Meeting Summary:

Conceptual Alternatives Meeting #2 - Discussion with Snohomish County Staff

MEADOWDALE BEACH COUNTY PARK FEASIBILITY STUDY

Meeting Date and Time: Thursday, February 26, 2015, 8:30 am to 10:30 am

Alternative 2: Existing Tunnel and Three Span Bridge, Separated Creek and Pedestrian Access Routes, 100% of Lower Lawn Converted to Habitat

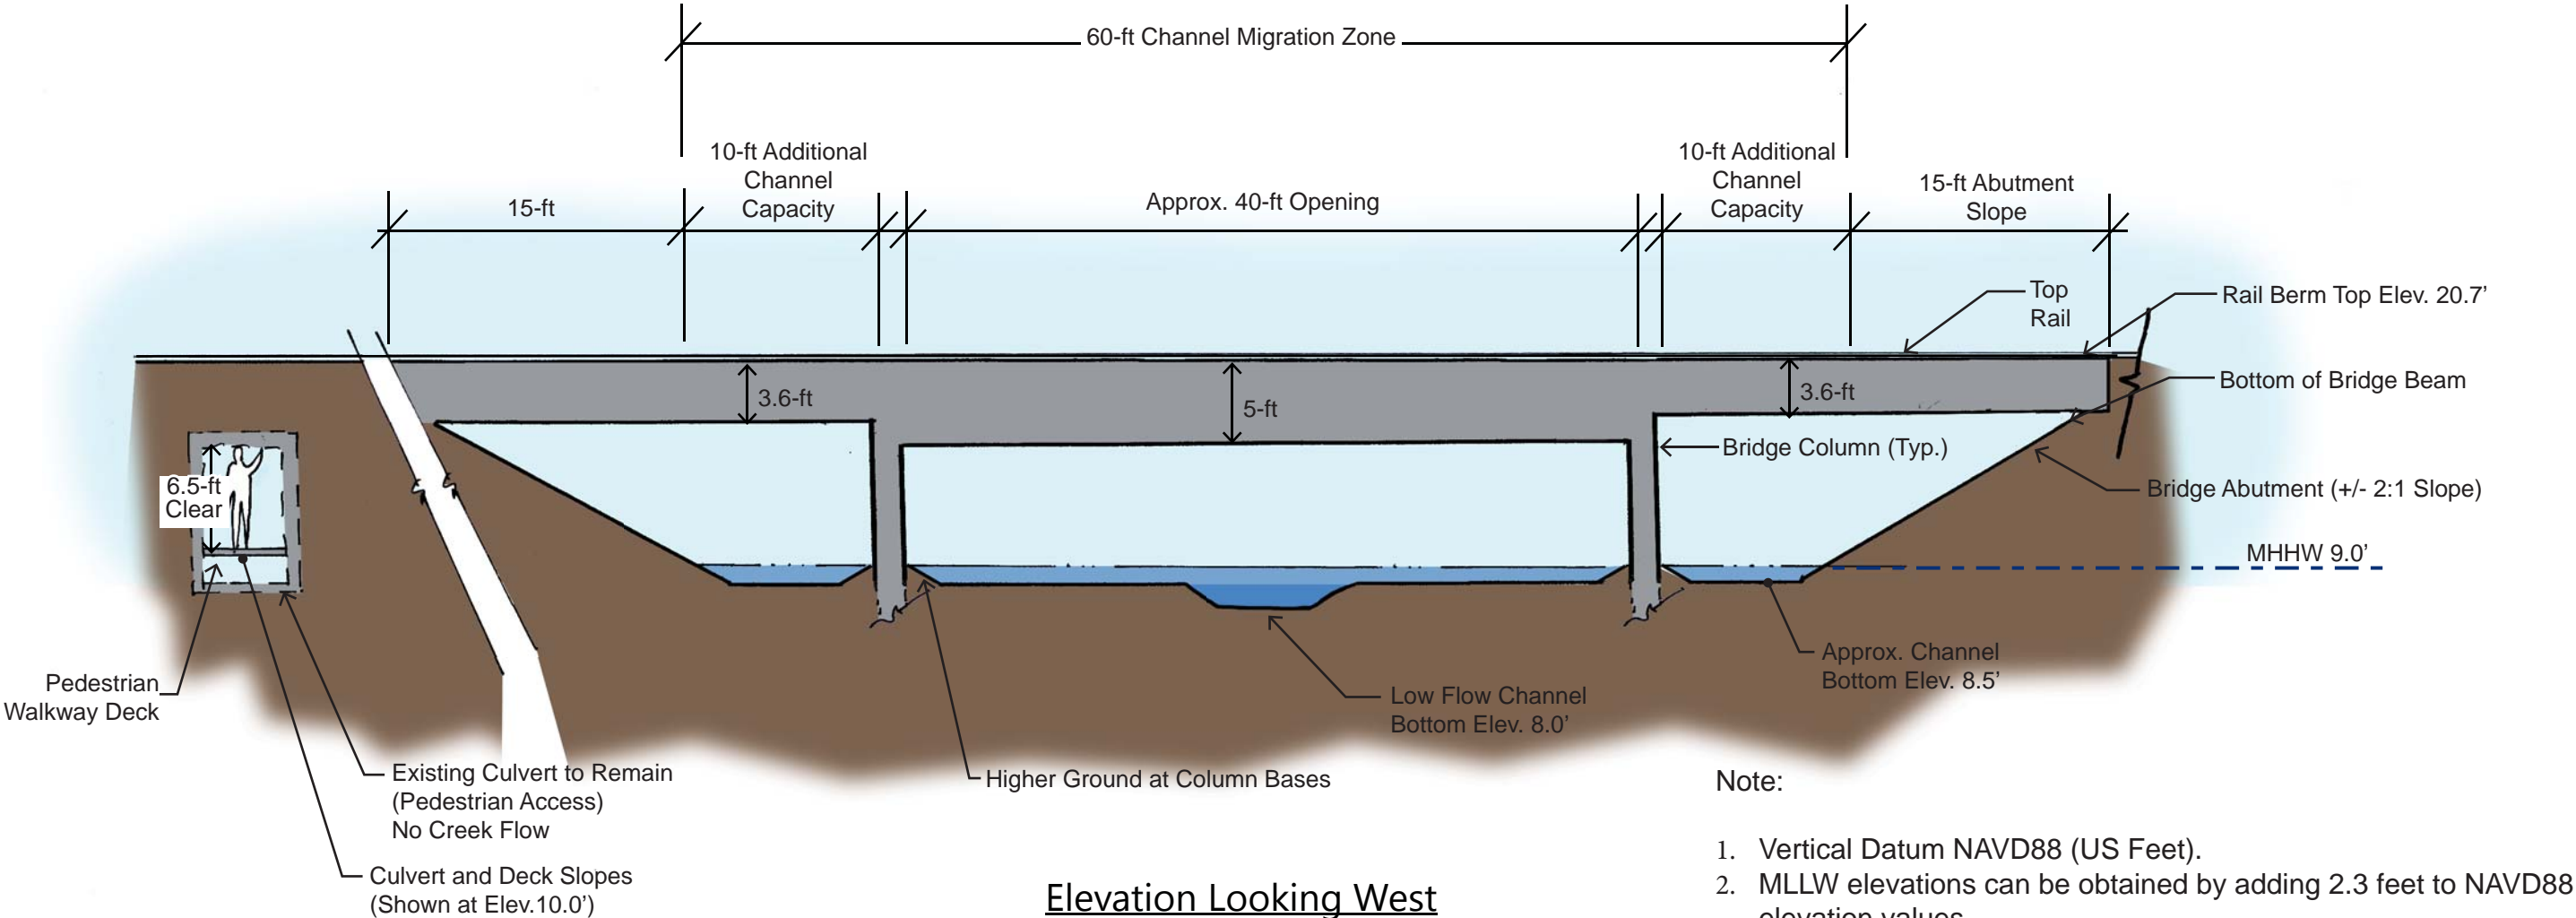
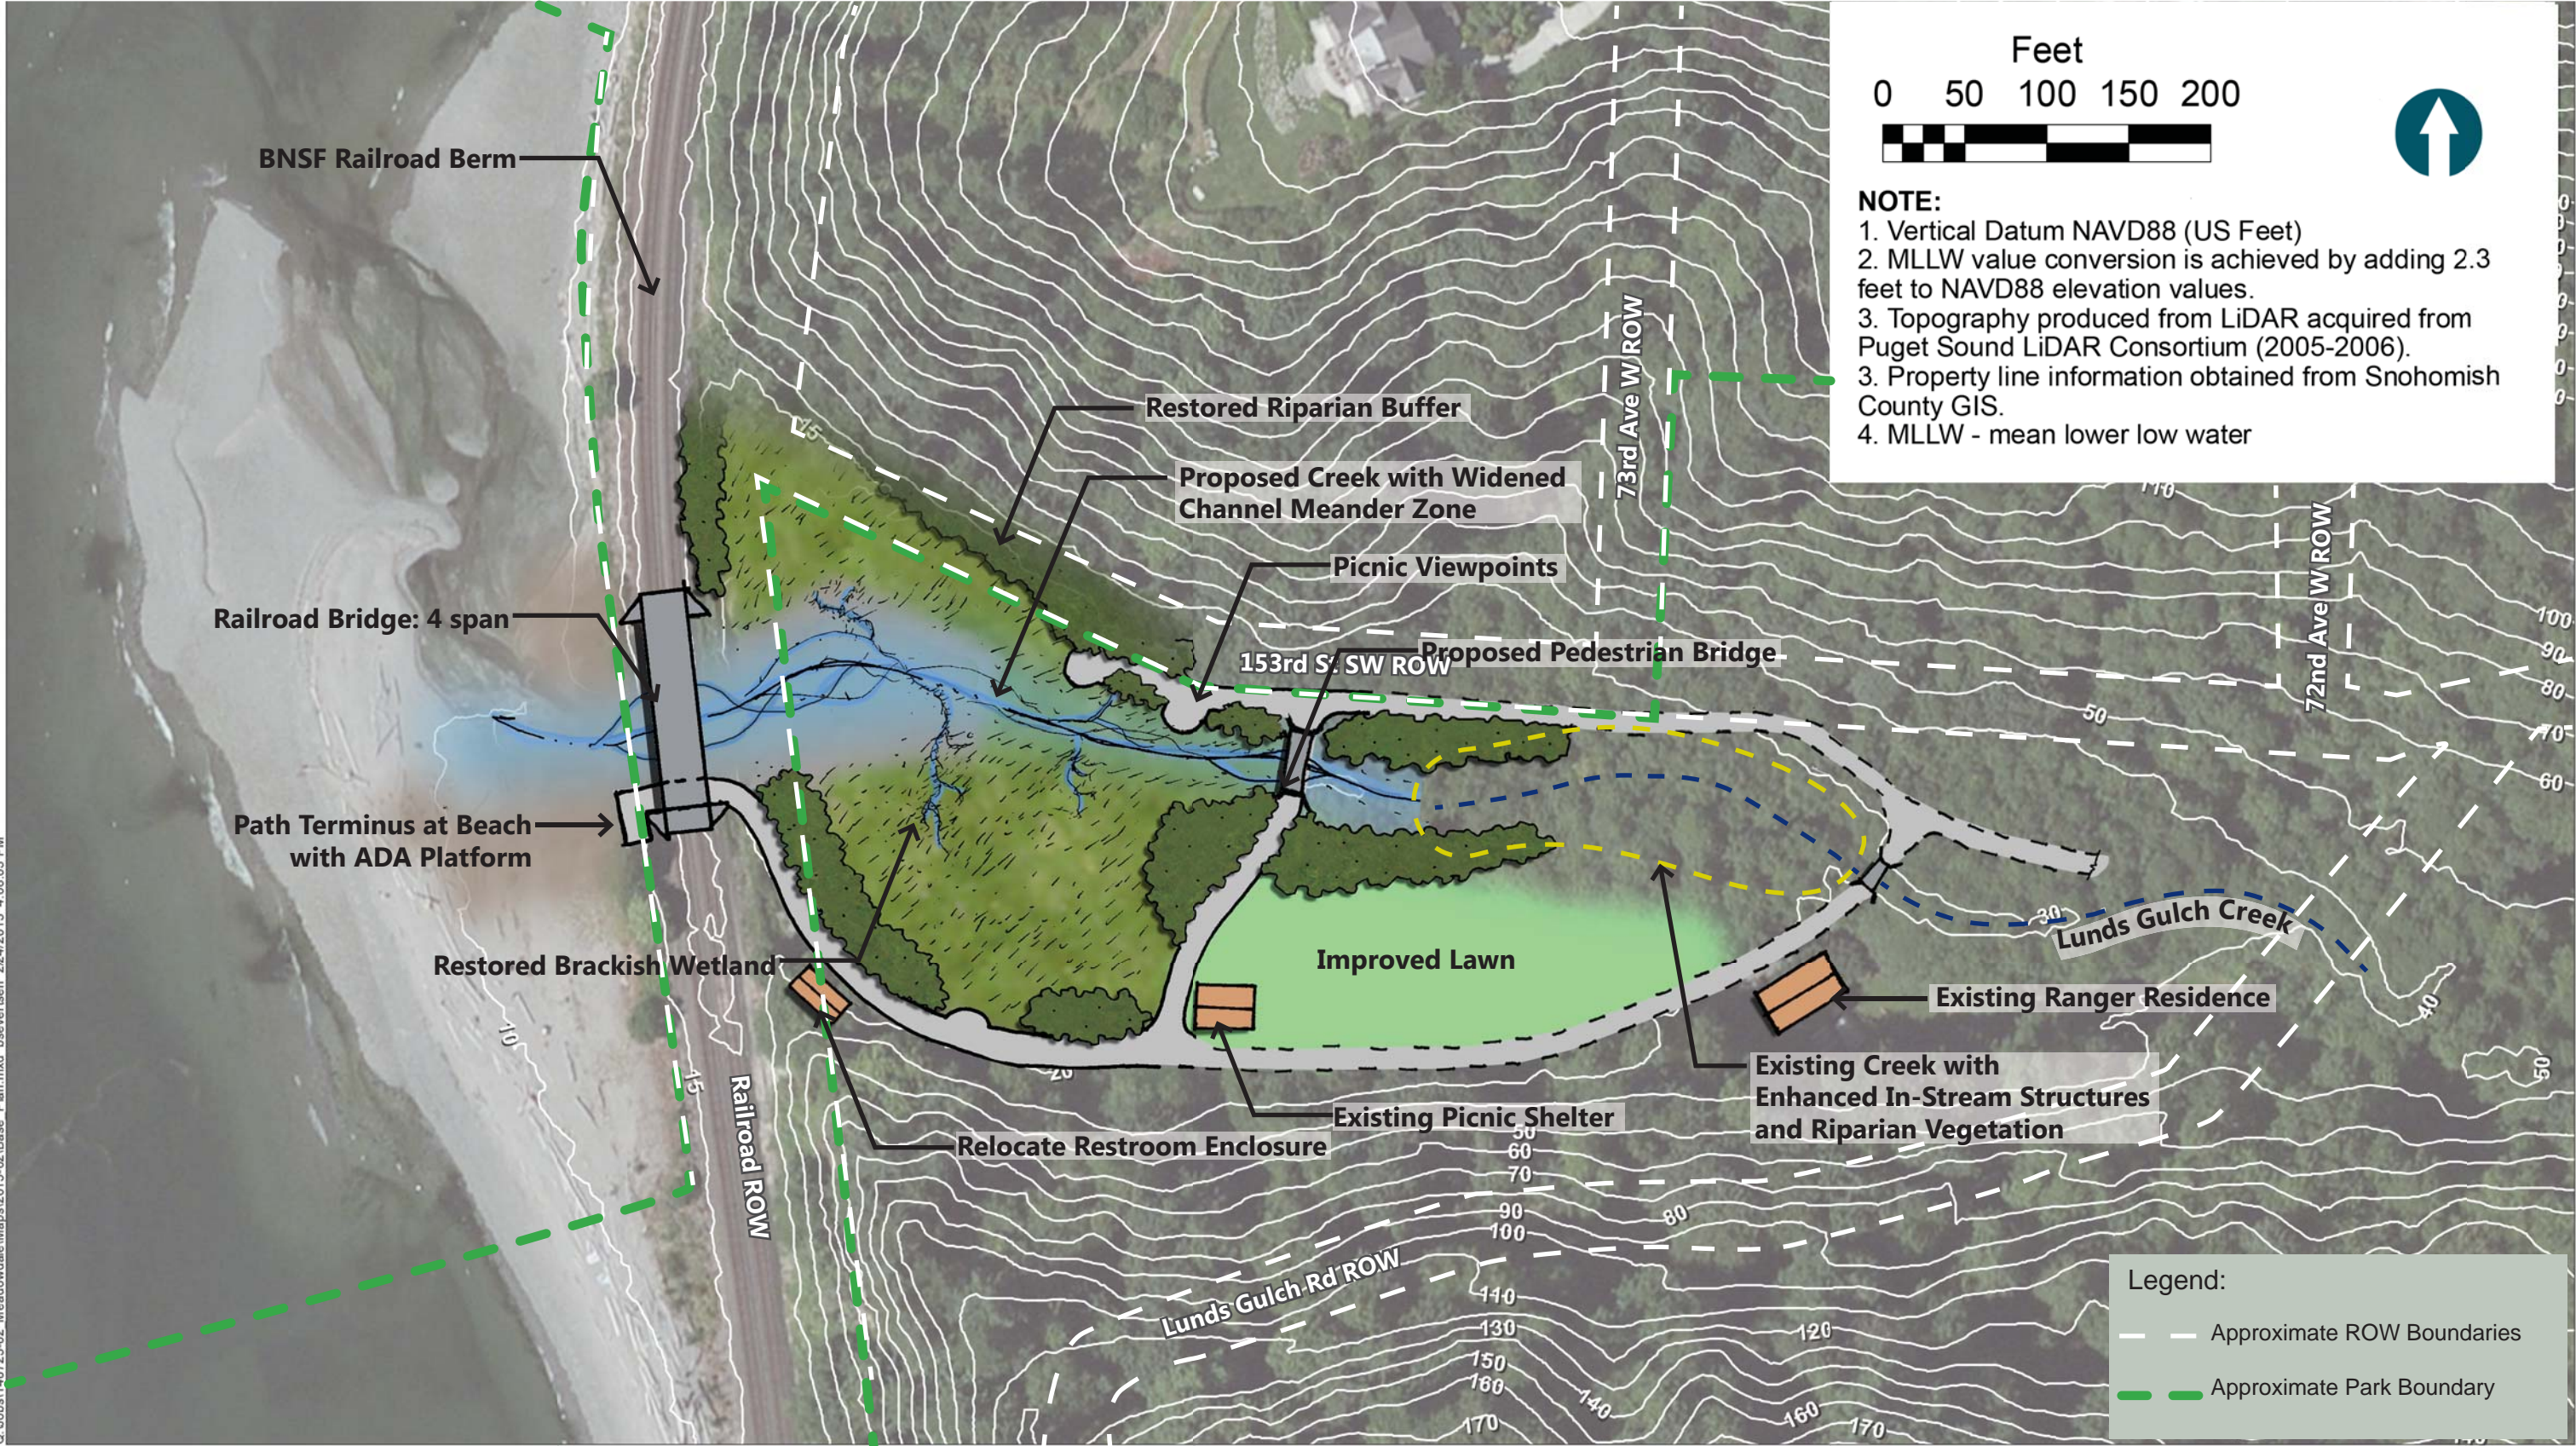
- Alternative 2: Retain the existing tunnel for pedestrian access and build a three-span bridge to the north of the tunnel location for the creek outlet. The bridge is the same size as for Alternative 1 above. The existing tunnel bottom would be modified to optimize the vertical clearance², but would be inundated during higher tides.

- While Alternative 2 is merited as a conceptual alternative because it provides additional separation between the creek and pedestrian access, s; the existing tunnel may be problematic for several reasons including height restrictions, potential migration of the relocated creek back towards the opening and potentially experiencing inundation from the same tides as the other openings.

- The consultant team will revise plan and section views of proposed alternatives based on results of this meeting and will submit revised plan/section views for the three proposed alternatives to the County. Revised concept figures are provided in Attachment 1 to this meeting summary.
- The consultant team will move forward with all of the studies as outlined in the scope of work (Task 5) to evaluate feasibility of the three revised concepts.
- The consultant team will move forward with collecting survey data on site as required to fill data gaps (e.g. height of the rail, geometry of the existing tunnel, channel thalweg elevations, etc.).

Alternative 3: Four Span Bridge, Combined Creek and Pedestrian Access Route, 100% of Lower Lawn and 30% Upper Lawn Converted to Habitat

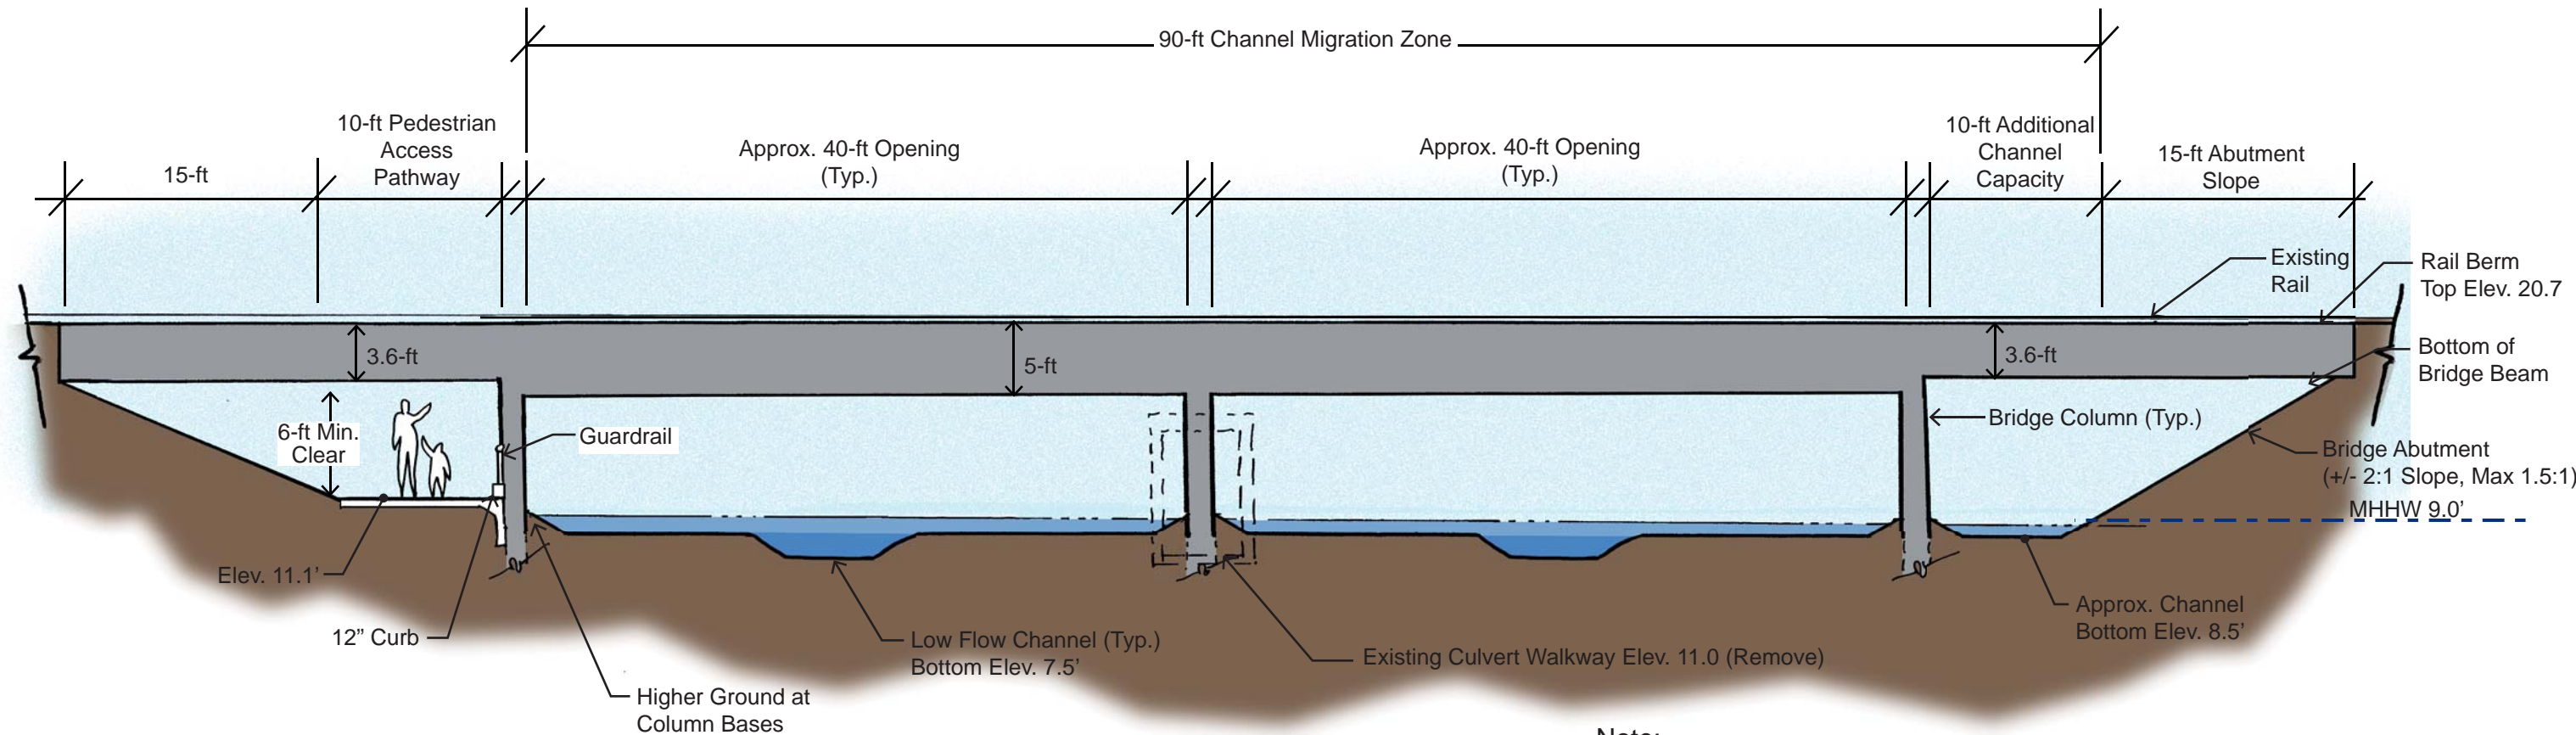
- Alternative 3: A four span bridge with two 40-foot clear spans and two 25' abutment spans. Creek outlet provided through the clear span and the north abutment span. Pedestrian access provided in the south abutment span (10-foot walkway width). The walkway height would be optimized to provide up to 6 feet of vertical clearance to maximize the amount of time the walkway would not be inundated by creek flows. The walkway in this alternative would be inundated during extreme high tides only.

- The habitat and recreational features shown for the three alternatives could be “mixed and matched” with a different opening size/type through the railroad berm. However, the larger habitat area shown for alternative 3, which has the

largest bridge opening, would likely be needed to accommodate the larger bridge opening and subsequent larger migration zone for the creek through the opening.
